Response to the editor

Response to reviewer's comments:

Figure 1. The 10-km buffer zone of RGI 6.0 glacier boundaries (a) and Sentinel-derived glacial lakes located near buffering boundary within the study area (b).

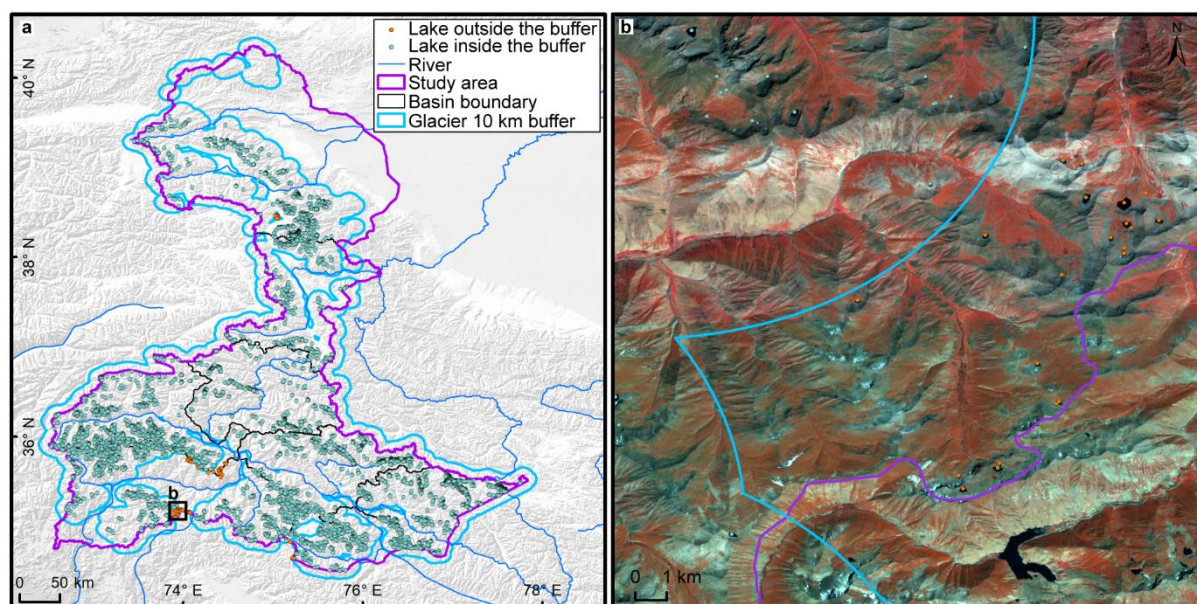
Their comment and frustration, evident in the statement "merely wanted to avoid using a spatial filter as it was "arduous"" is using the word 'arduous' from your manuscript. If there is/are a different reason(s) for those methods, you can clarify the text in the next revision.

[Response] To avoid any misunderstanding, we deleted the sentence that contains 'arduous'. We also revised this paragraph on Definition of glacial lakes and added one new Figure 3 for clarity.

Now it reads 'A 10-km buffering distance of RGI 6.0 glacier boundaries that has been widely used in previous studies (Zhang et al., 2015; Wang et al., 2020), was created to help mapping glacial lakes. A few glacial lakes (a total of 84 lakes for Sentinel-2 dataset and 55 lakes for Landsat dataset in 2020) beyond the buffering zone, located near buffering boundaries, were intentionally included due to clear evidence of glaciation (Figure 1).'

Figure 2. Estimated relative error for glacial lakes of all or specific size ranges in study area. Error estimation is based on the modified equation and lake data extracted from Landsat (a-d) and Sentinel-2 images (e-h).

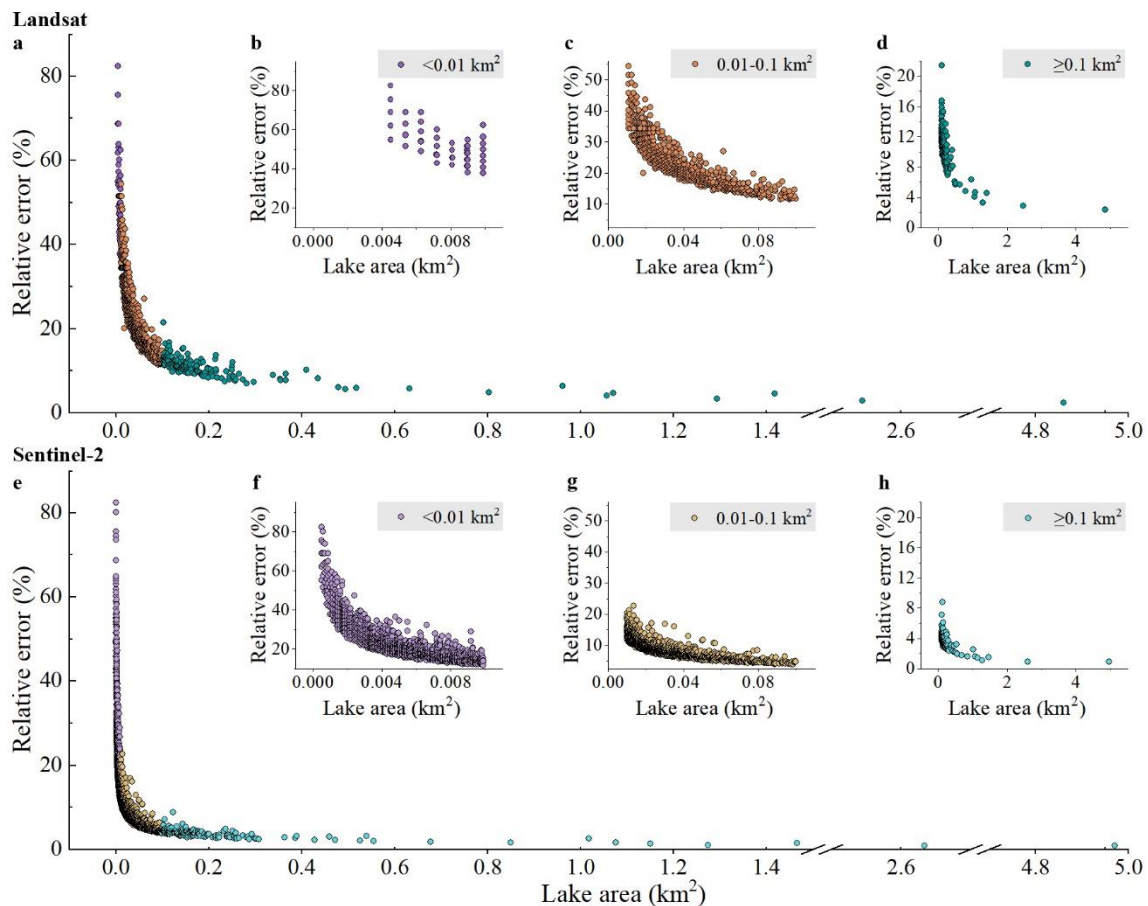
Similar to my interpretation of reviewer comments, I am concerned there is a lack of detail and precision throughout the manuscript. Many reviewer comments request more careful wording. Somewhat related, I note that Figure 4c is cut-off at ~35 % relative error, but Figure 4a appears to have brown dots up to ~60 %. The figure caption should more clearly describe what is being shown, that sub-panels are repeating data zoomed in (not something new/different (unless I'm mis-interpreting it)), and if any data is missing/cut-off/discarded, and if so, why.

[Response] We have to thank you again for pointing out the errors. We added a new Section '6.1 Error and uncertainty of lake mapping' to present relative and absolute errors in lake mapping, as also suggested by the reviewer 3. More detail can be read at Section 6.1.

We have fixed the mistake in previous Figure 4 (now Figure 8). Revised as below:

Figure 1. Location of the study area associated with distribution of glaciers (RGI Consortium, 2017), mountains, basins and population (Rose et al., 2021) (a), and its

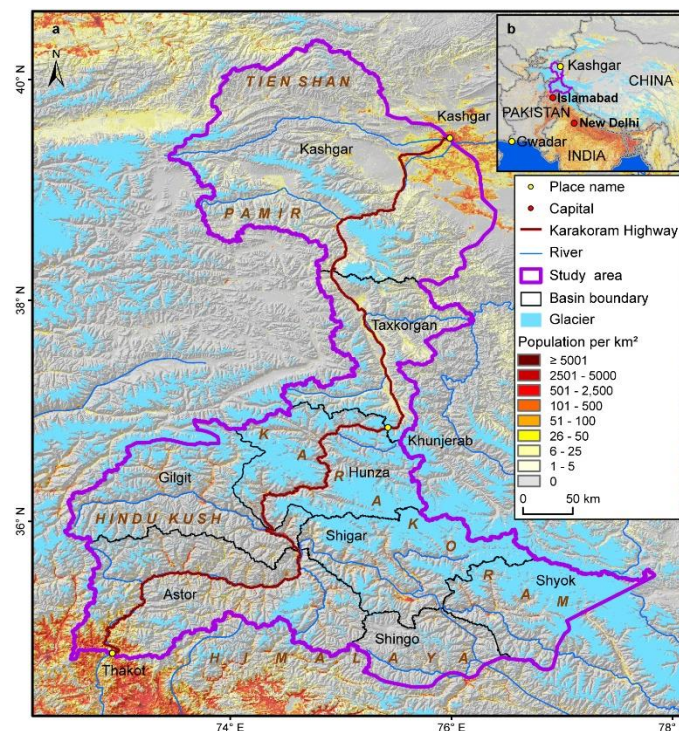
Figure 1: Recommend labelling the two panels to refer to in the caption, improving legibility of coordinates (by moving outside map or using a white background as for the legend), referencing source of layers such as glacier area and population count in the caption, and perhaps consider also labelling countries in the inset.

[Response] Thanks for your valuable advice, the Figure 1 was modified accordingly and the references for glacier and population count were added.
